**EAST HARTFORD-GLASTONBURY
ELEMENTARY MAGNET SCHOOL PHASE 2
GLASTONBURY, CONNECTICUT
STATE PROJECT NOS. 054-0095 MAG/N/PS & 054-0096 MAG/N/PS
GLASTONBURY BID NO. GL-2011-04**

The following changes to the Drawings and Project Manual shall become a part of the Contract Documents superseding previously issued Drawings and Specifications to the extent modified by this Addendum No. 5. Bidders shall ensure this addendum is acknowledged in the appropriate space provided on the Bid Form when submitting their bid.

SSK-12

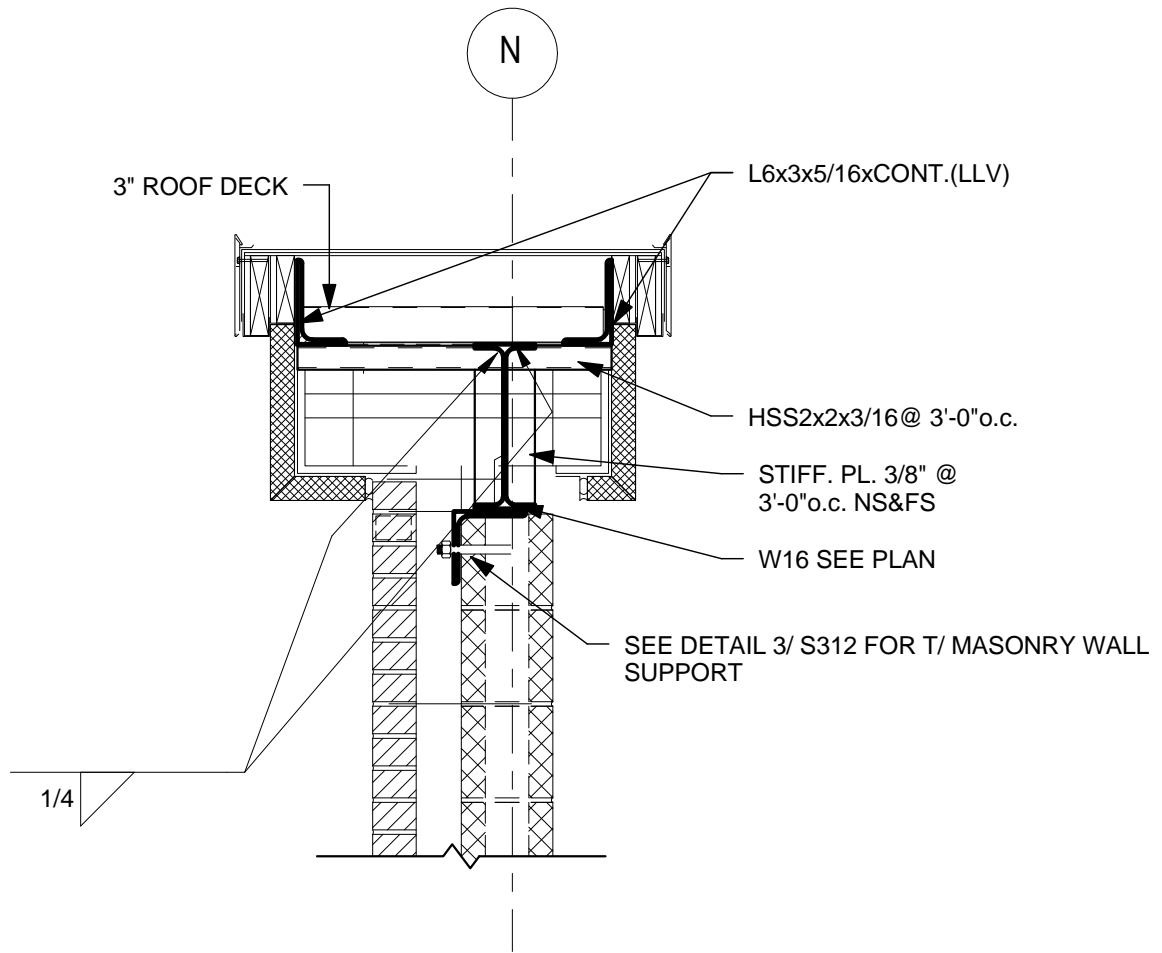
RESPONSE: Please see attached sketch SSK-12, Which clarifies detail at 6/S312

SSK-7

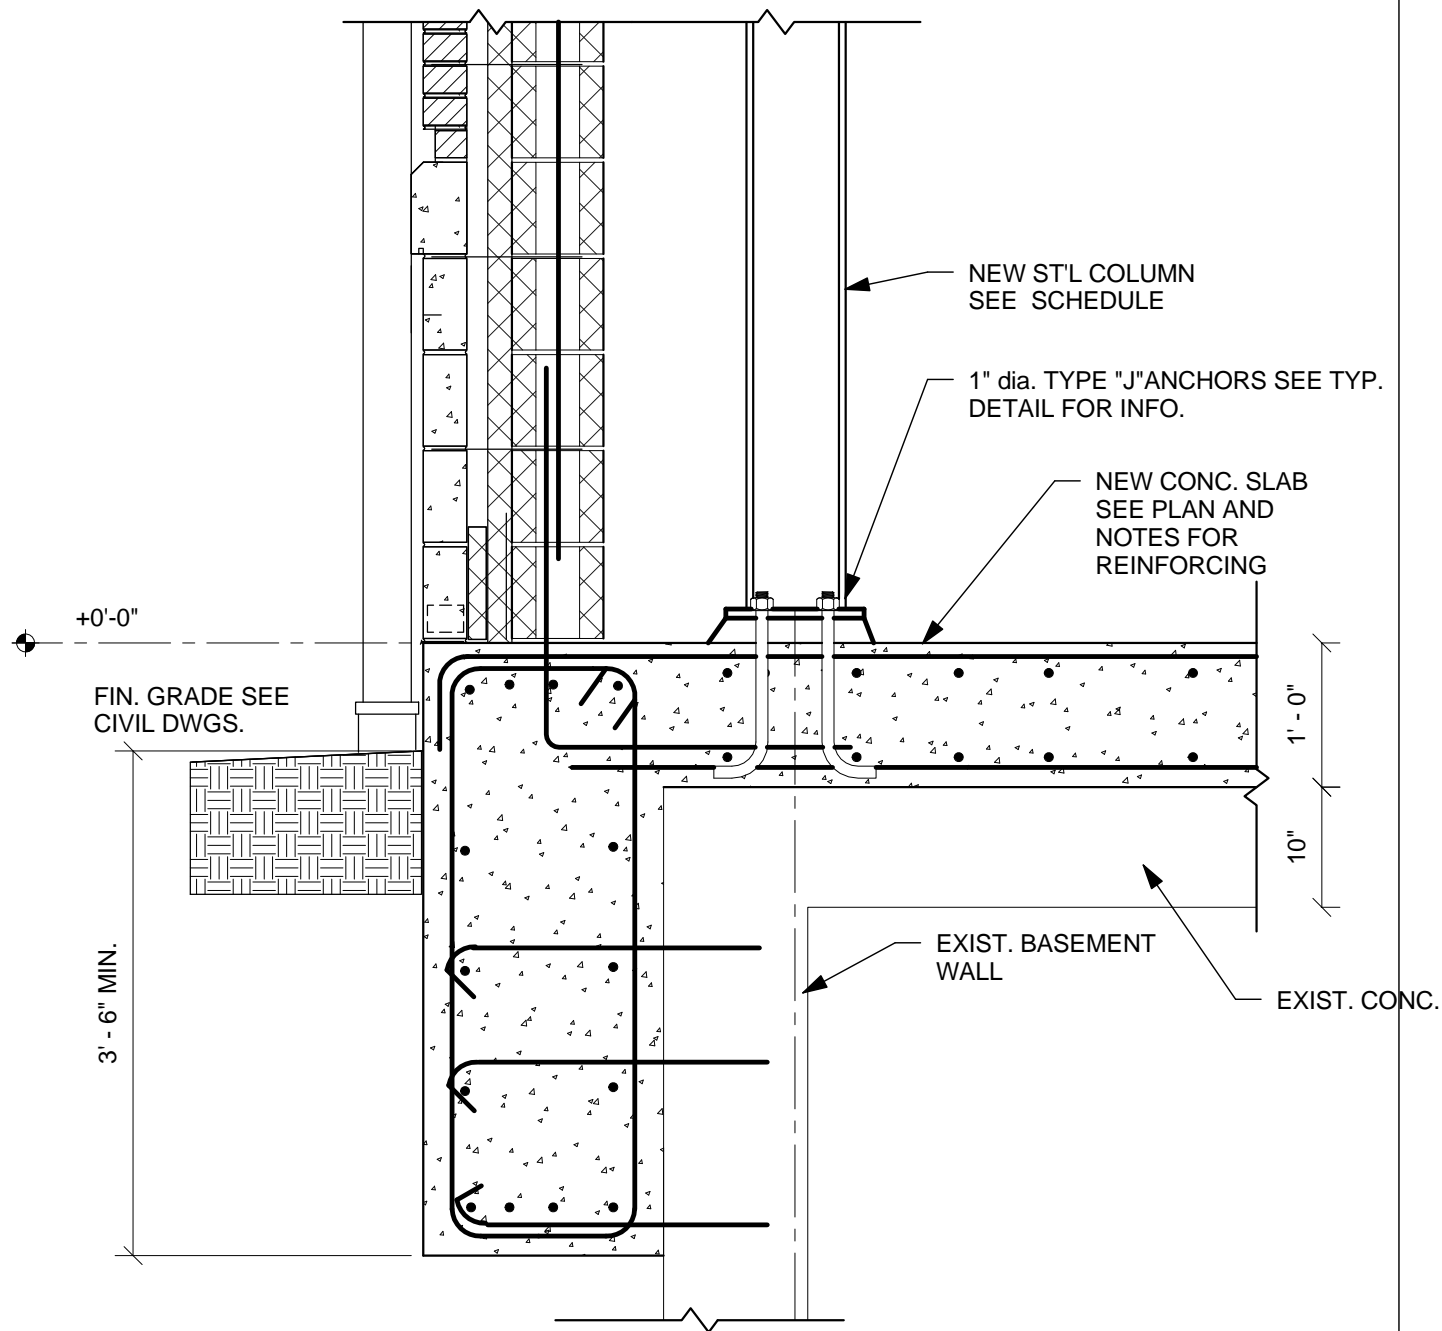
RESPONSE: See attached Sketch SSK-7.

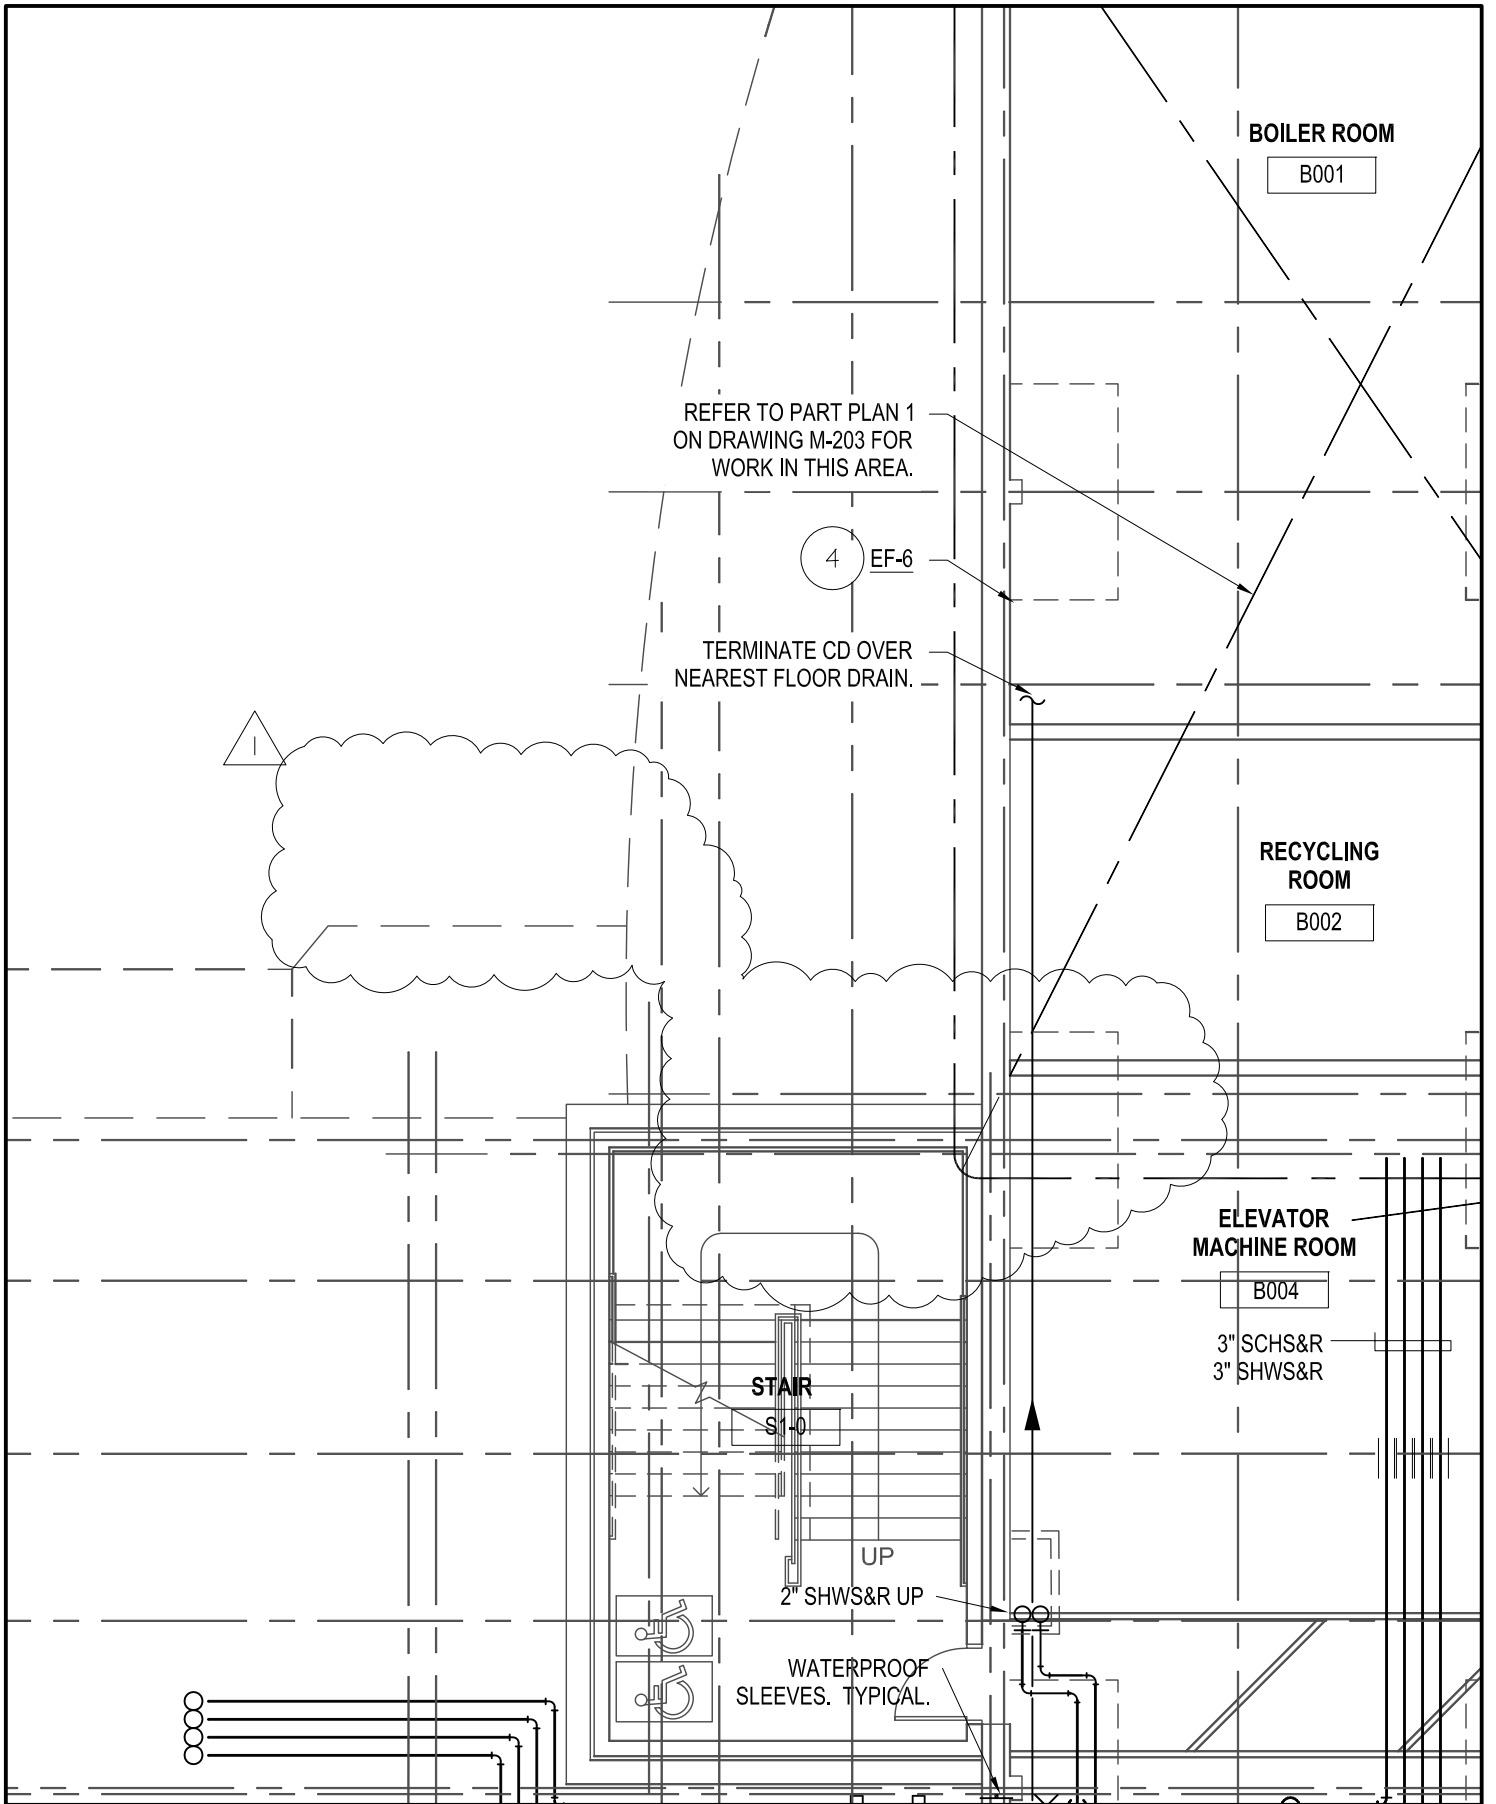
- 3) ADD clarification for material and installation of evaporative condenser drain in Note #2. DELETE original note relating to piping material, etc. from MP-100.2 as indicated on Sketch SK-MP-100.2-1 dated 2/21/11 (copy attached).

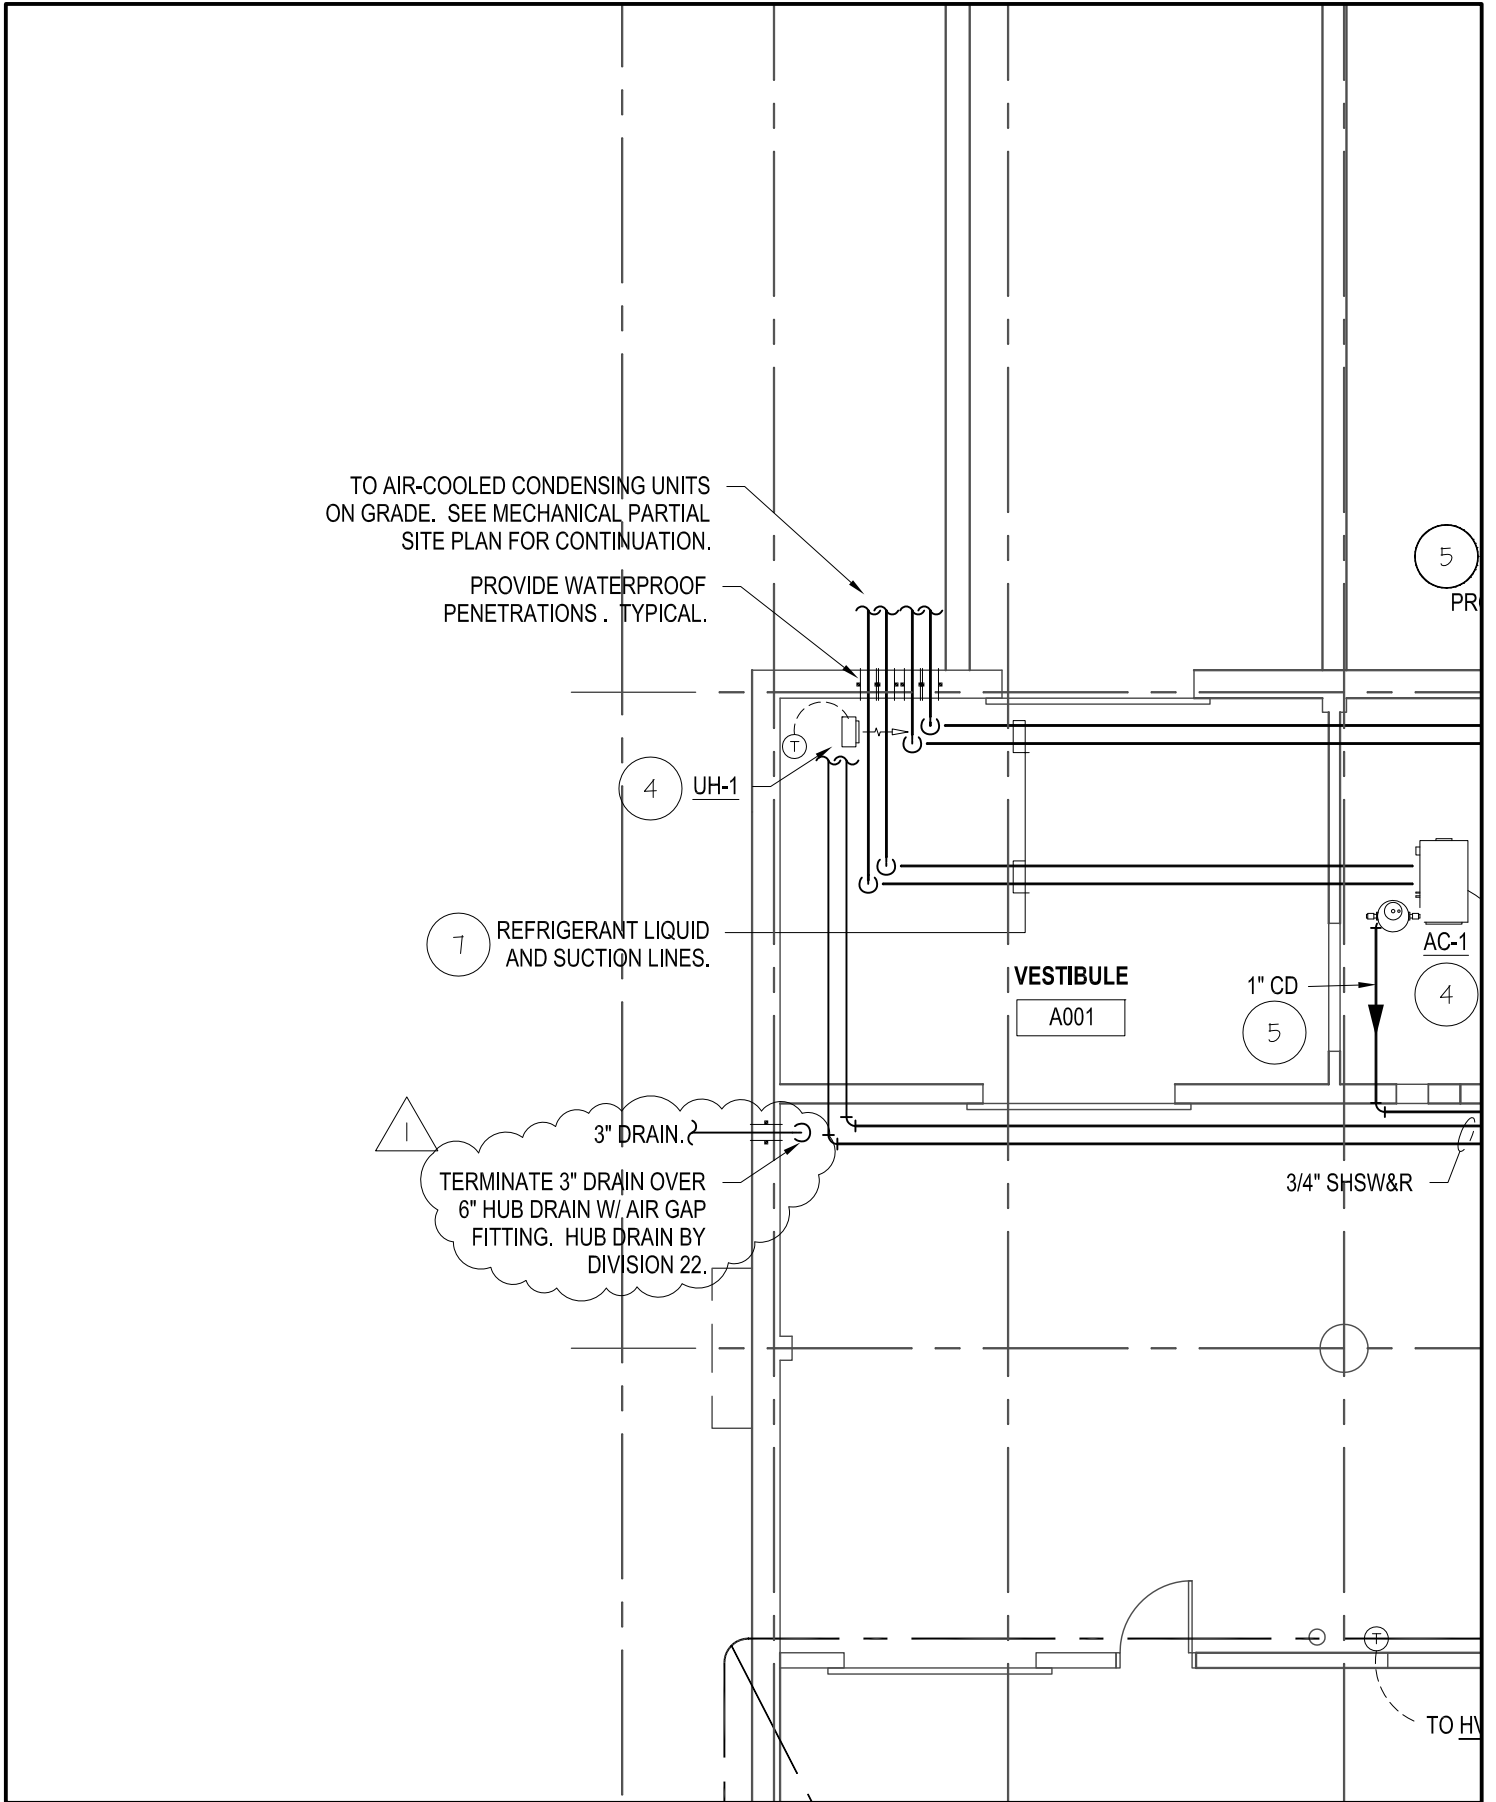
- 1) Revise location of 3" drain to new 6" hub drain as indicated on Sketch SK-MP-100.1-1, dated 2/21/11 (copy attached).

- 1) Remove a portion of the 3" drain and associated information from evaporative condenser to the duplex sump pump pit in Lower Level. Duplex sump pit no longer exists. See Sketch SK-MP-100.1-1 (copy attached) dated 2/21/11 for revised location of 3" drain.

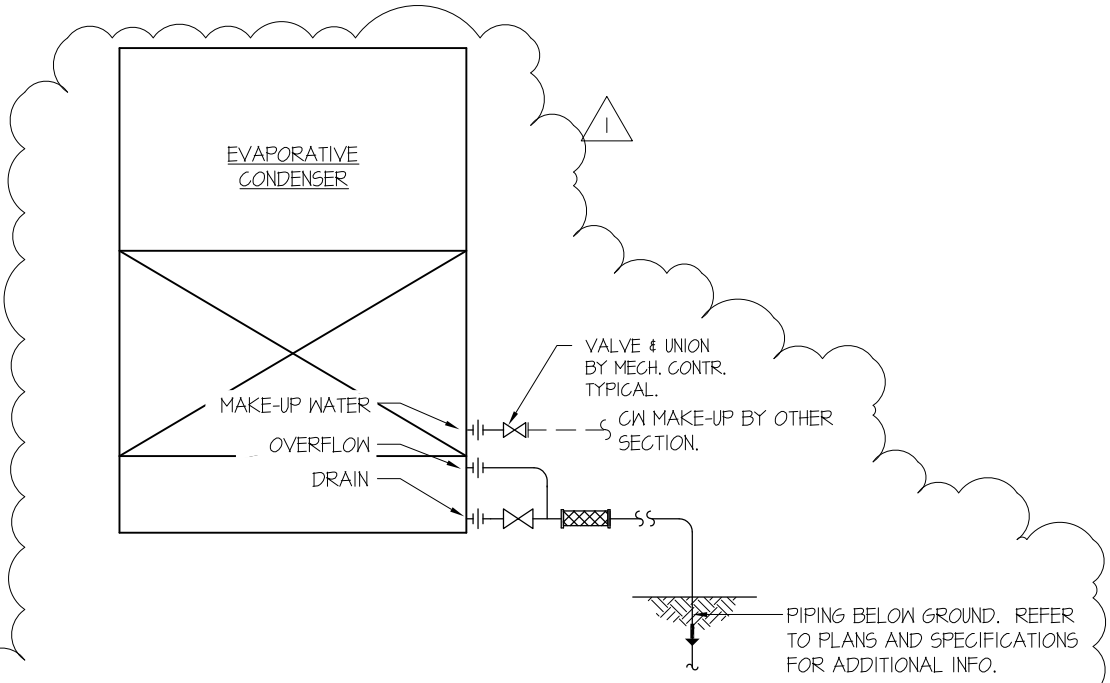
- I. DRAWING NO. M-406 –MECHANICAL DETAILS:
- 1) ADD Detail No. 8 - "Evaporative Condenser Piping Arrangement" as indicated on Sketch SK-M-406-1, dated 2/21/11 (copy attached).
